FOR PERMIT

Annex Courthouse - South End
Exterior Security Wall

Annex Courthouse - South End Exterior Security Wall

ELECTRICAL SITE PLAN

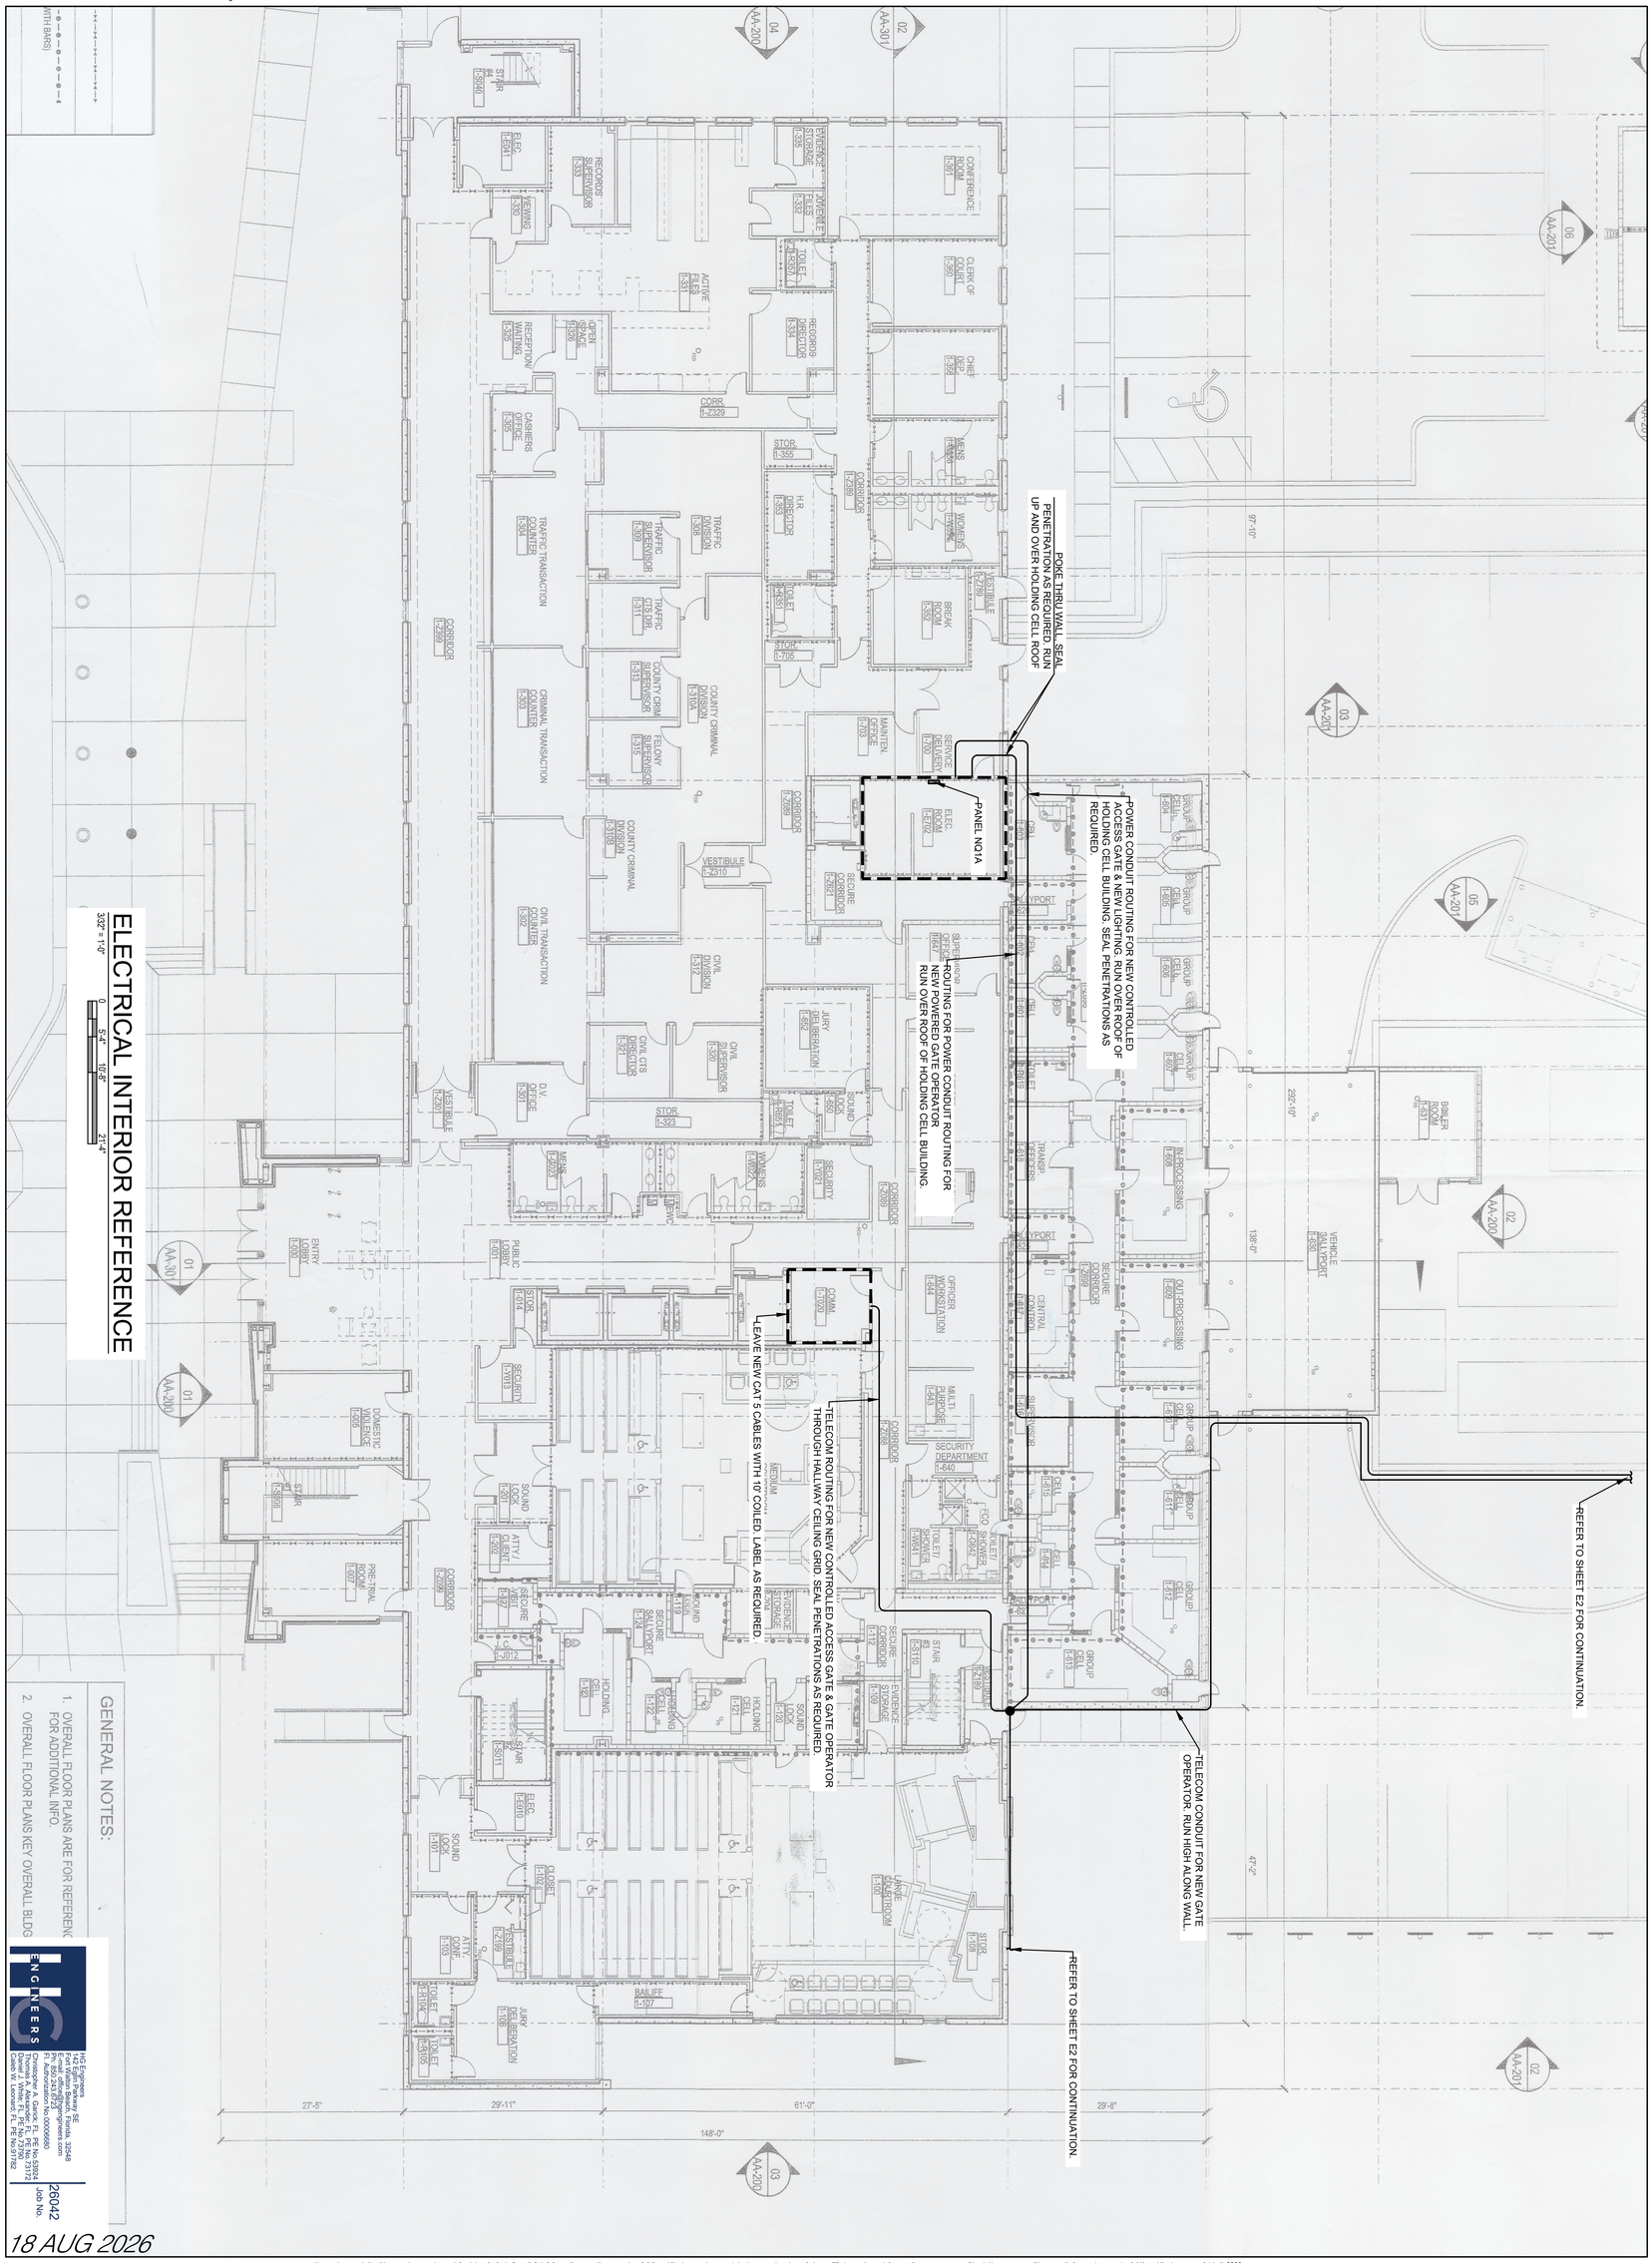
One 3/4 inch conduit is required with 4 wire low voltage combo cable for man door access control. No 110 voltage or CAT6 required at this location for telecom needs. 110 voltage is required for lighting and provided in separate conduit.

Conduit is required with 4 wire low voltage combo cable for vehicle gate access control. There is currently no plan for automation and this install would future proof just in case. No 110 voltage or CAT6 is required at this location for telecom needs. However, power is still required for lights and gate opener. Conduit will need to route all the way to the opener itself, not just to the inside wall as shown on plans.

Both combo cables for access control will route back to the electrical room where they will connect to the security node, which will require CAT6 ran from 1st flr comm room.
